TOWN OF BAY HARBOR ISLANDS PLANNING AND ZONING BOARD

April 17, 2018

Subject: Site Development Plan Application – Revision #1
Atlantis of Bay Harbor – 28 DU Multi-Family Residential Complex
10281 West Bay Harbor Drive
Bay Harbor Islands Acct. No. MB2017-21
MMPA Acct. No. 01-0702-1049

Below are all of the changes since the PZ Board approved the plans on March 21st, 2017:

SIGNATURE		DATE	
NO.	REVISION	DATE	BY
DRAWING TITLE:			
SIDE ELEVATION			
SCALE: 3/32"=1'-0"		DATE: APRIL 3, 2018	
SHEET NUMBER:			
A-2.02			
P&Z REVISIONS

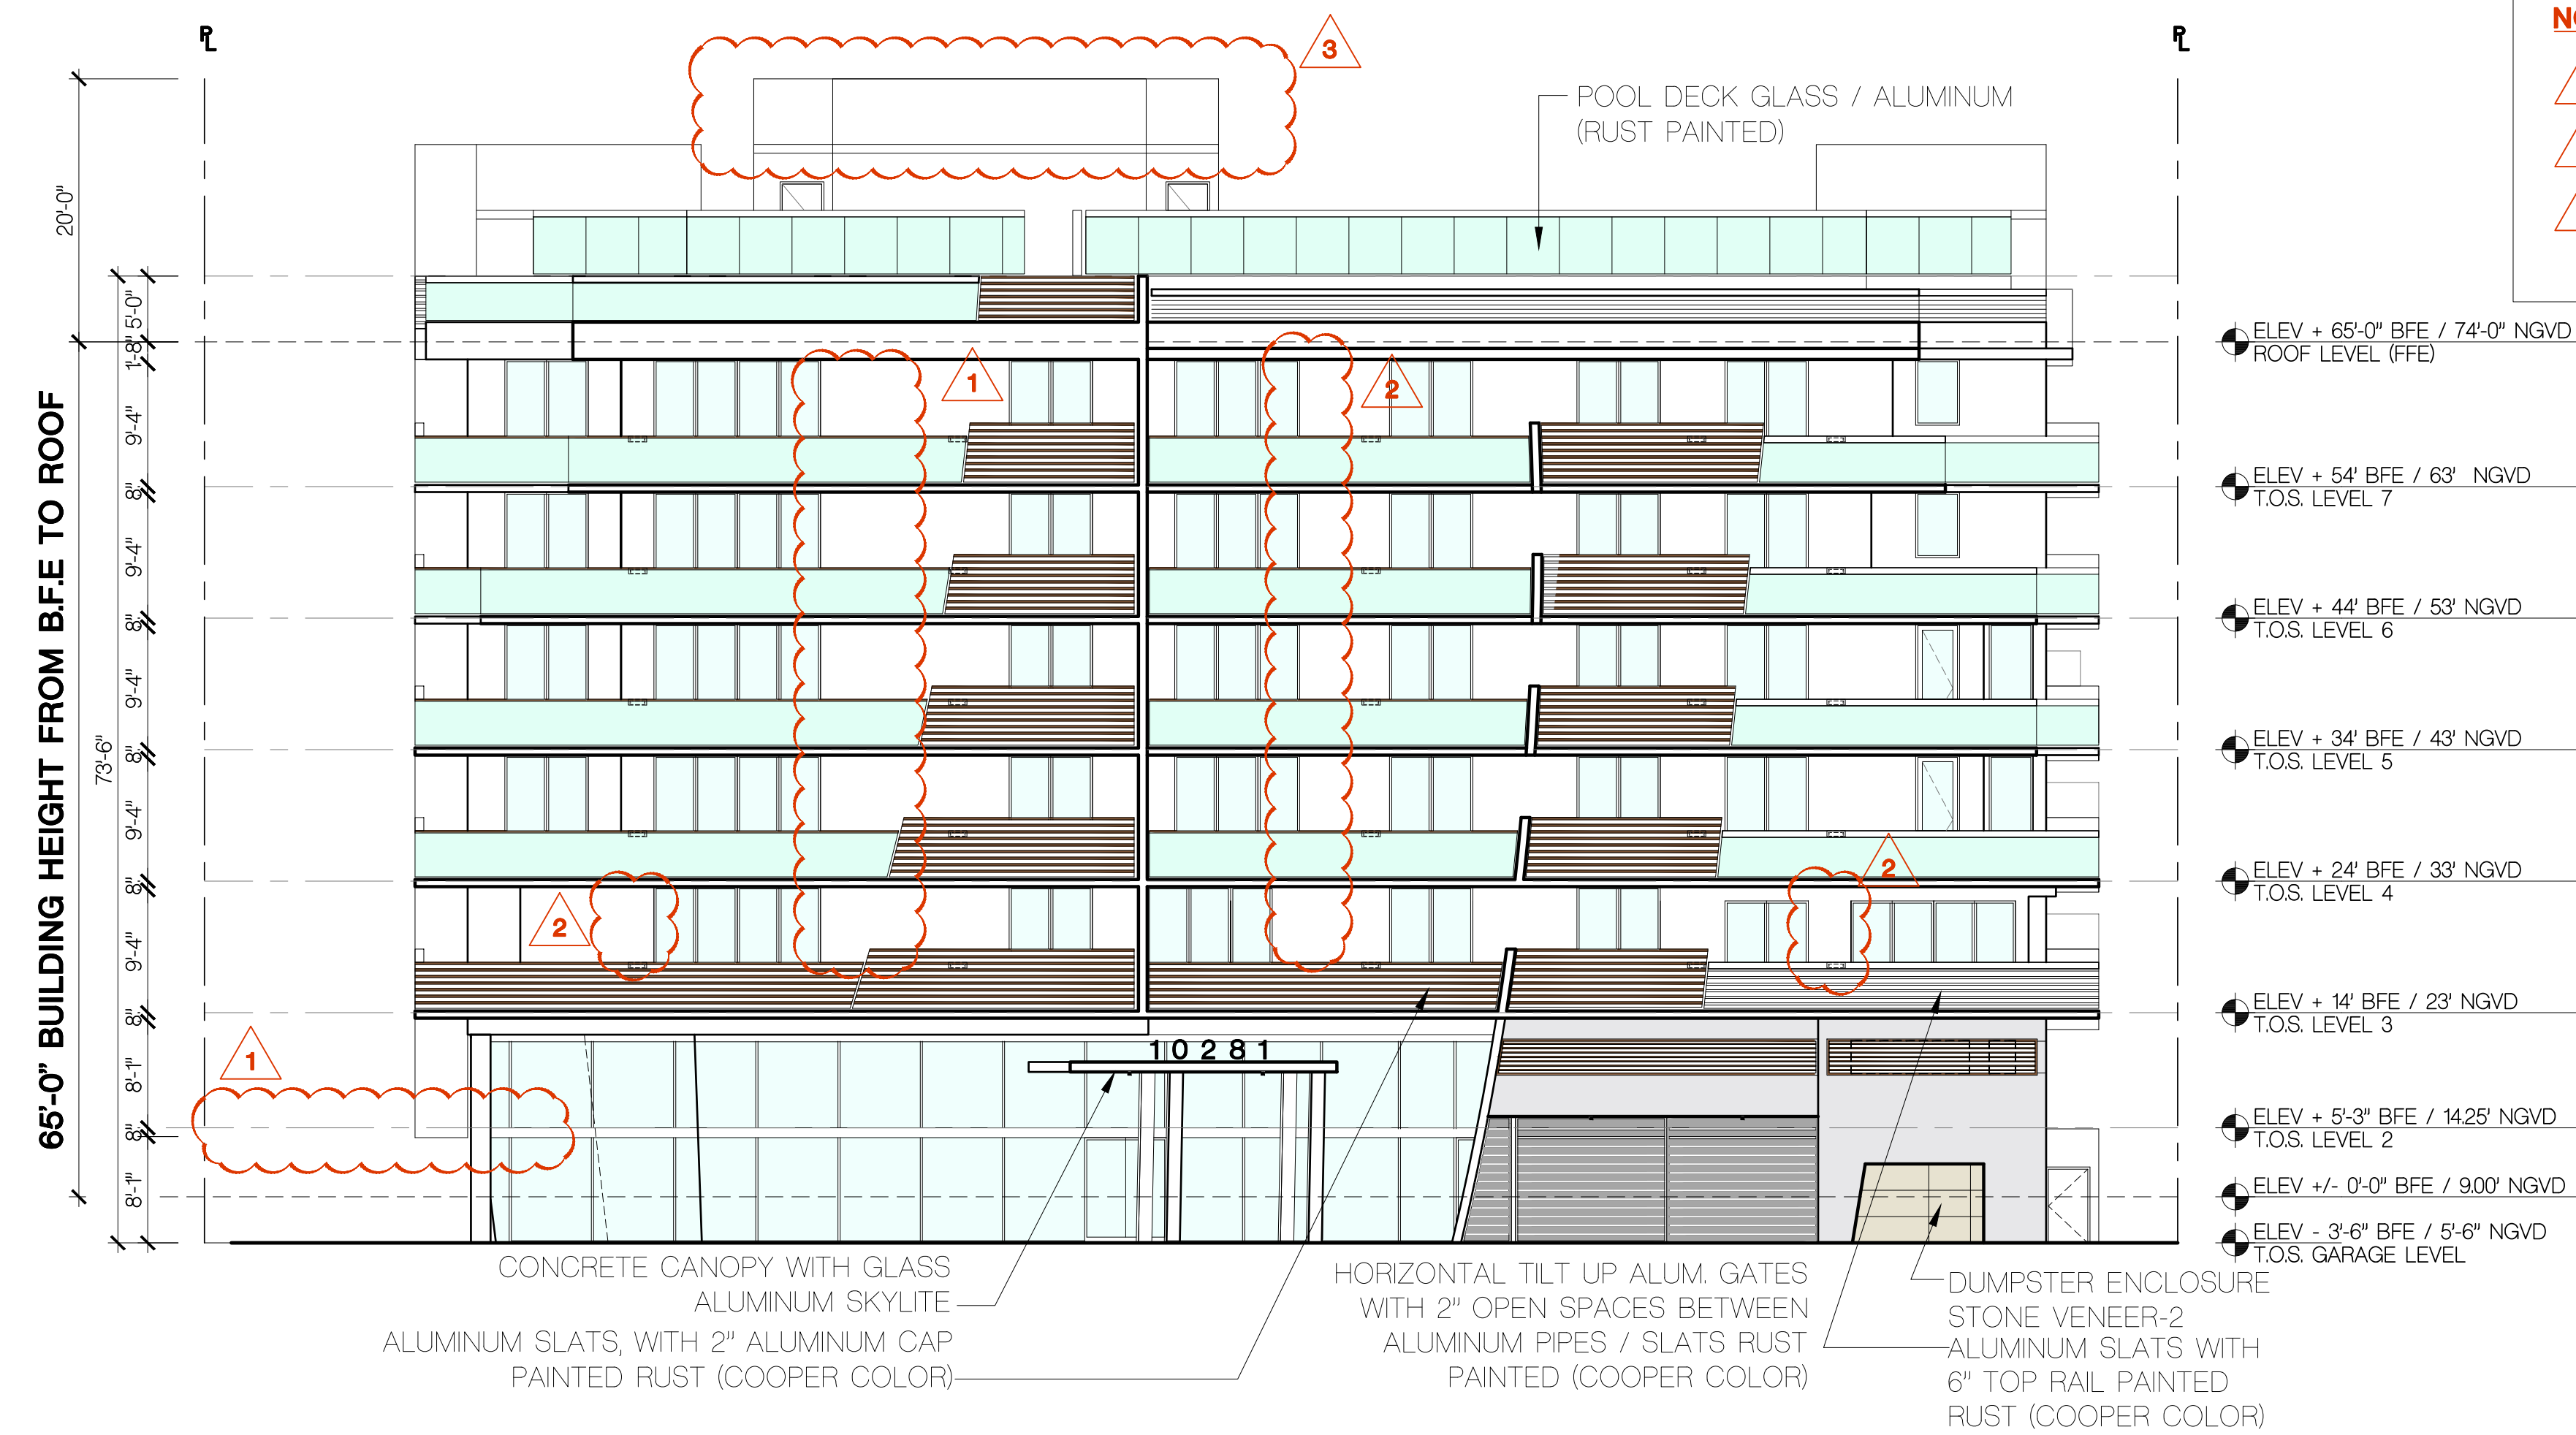
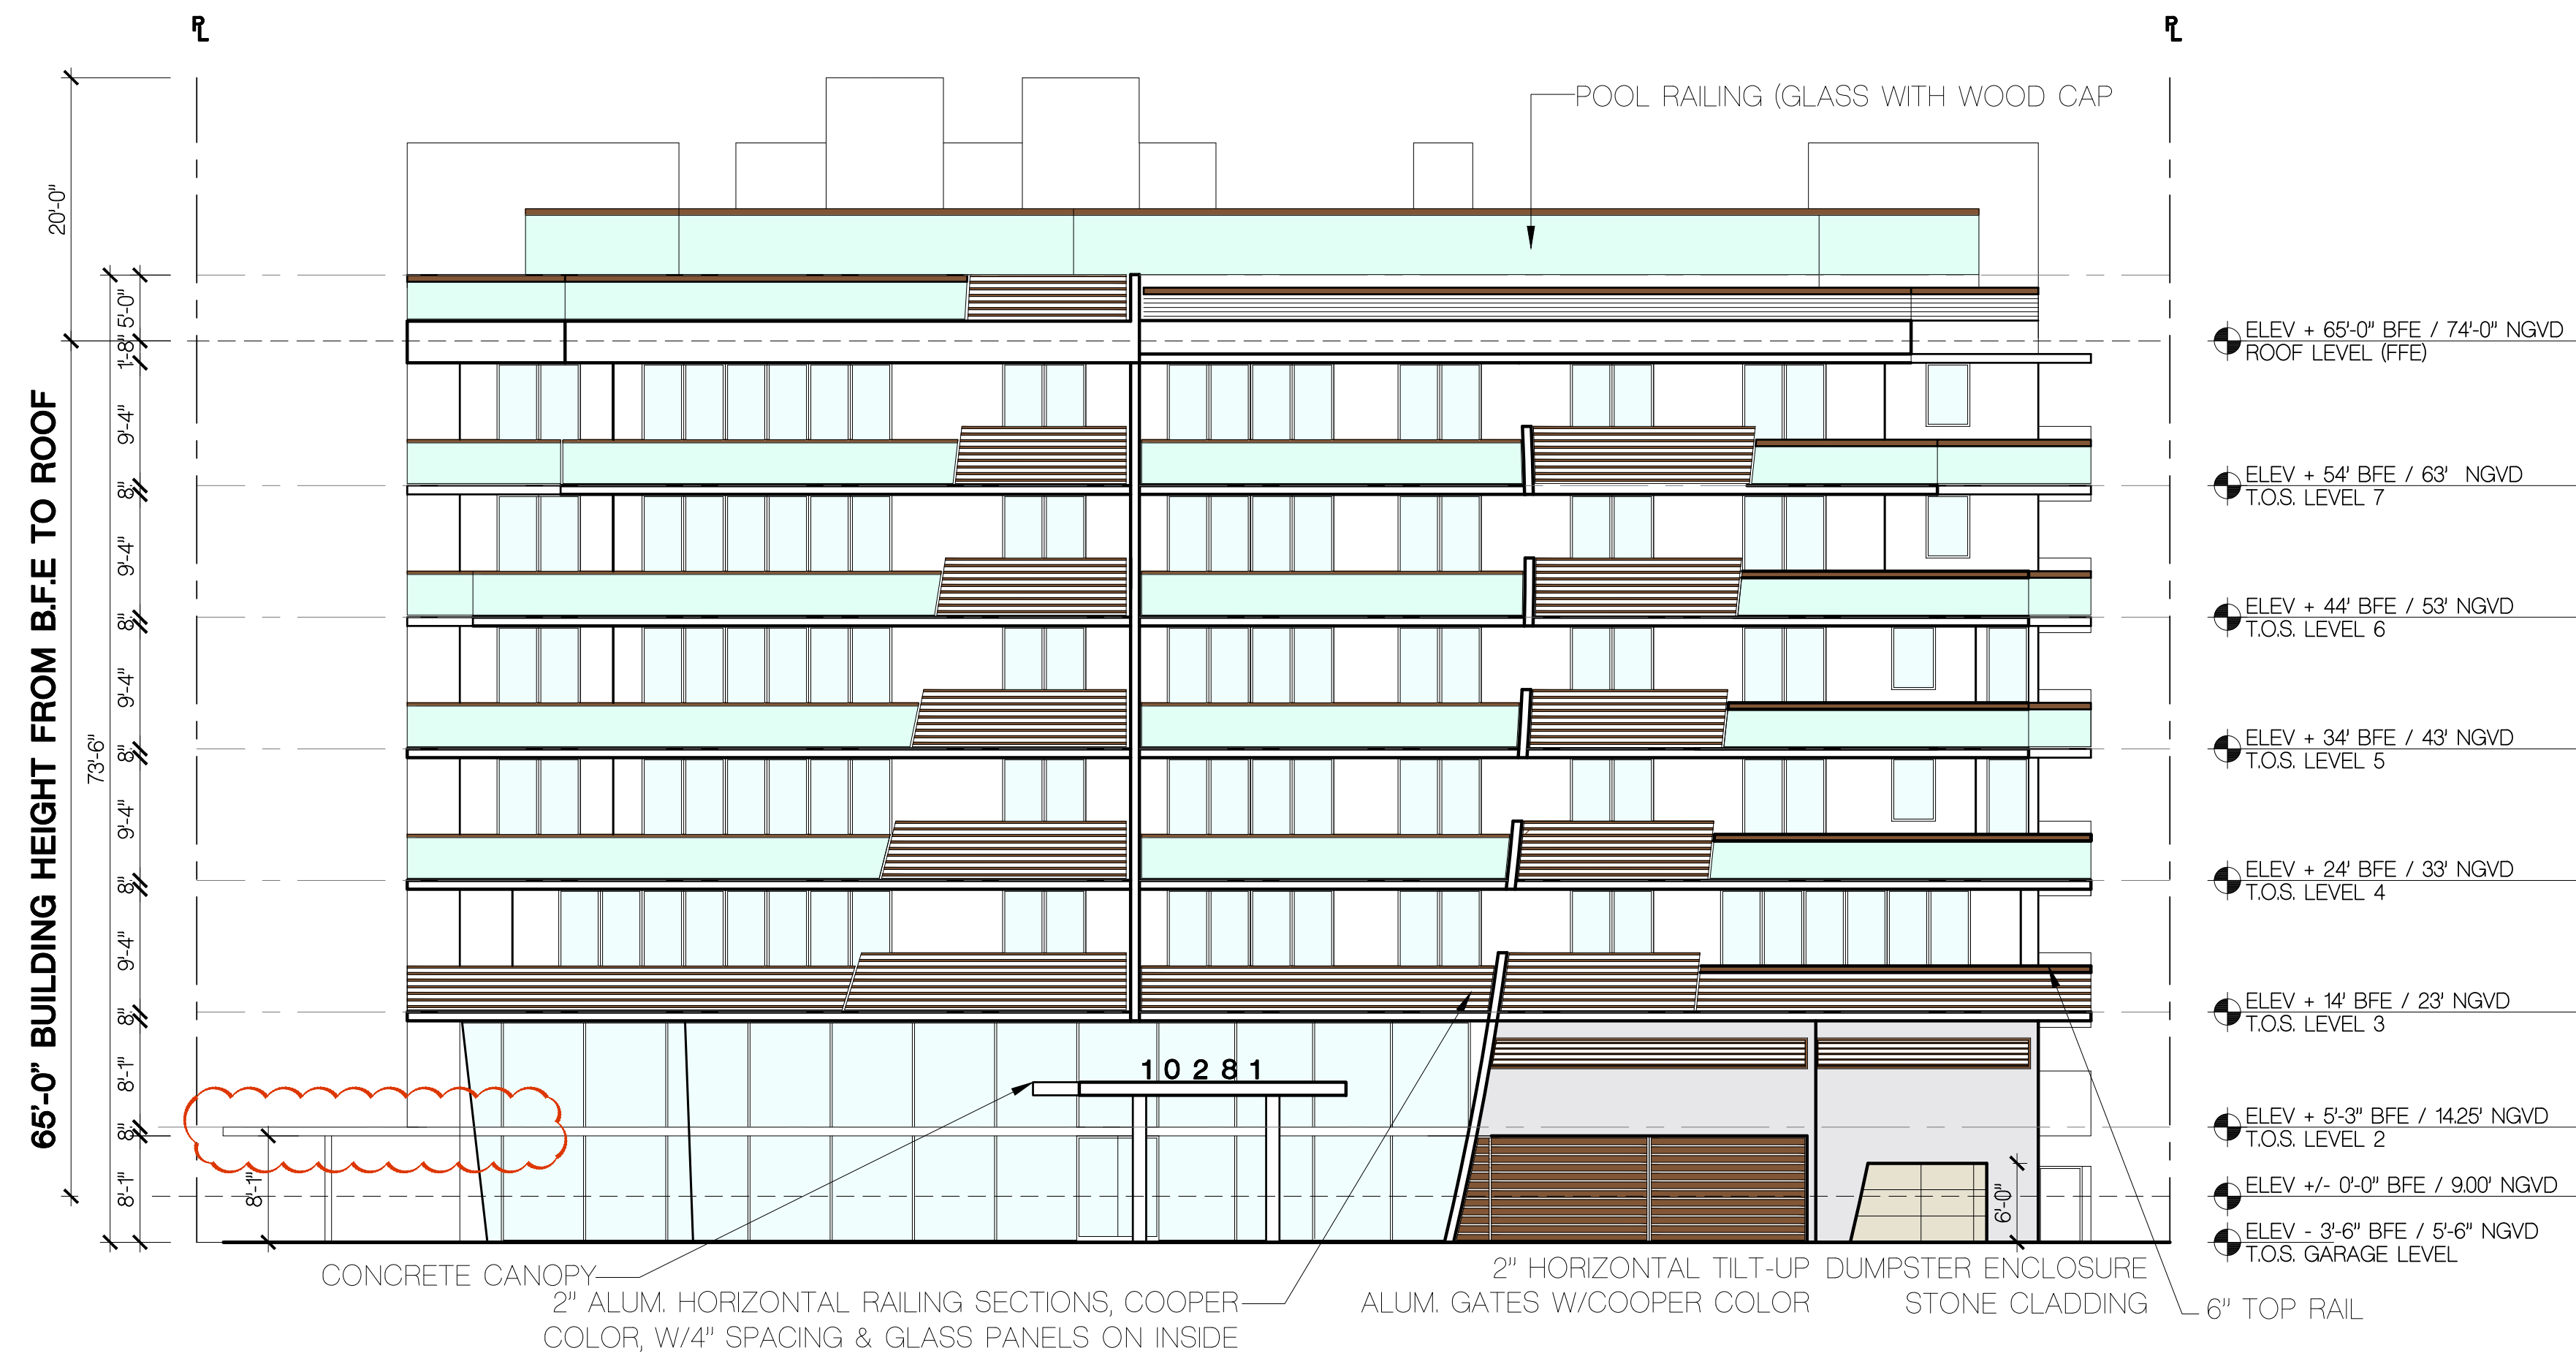
- 1 REMOVE CANOPY ABOVE WEST WALKWAY @ WEST
- 2 REDUCE GLAZING AREA.
- 3 ADDED PARAPETS ABOVE THE ELEVATOR LOBBIES TO CONCEAL THE ROOF-TOP MECHANICAL EQUIPMENT.
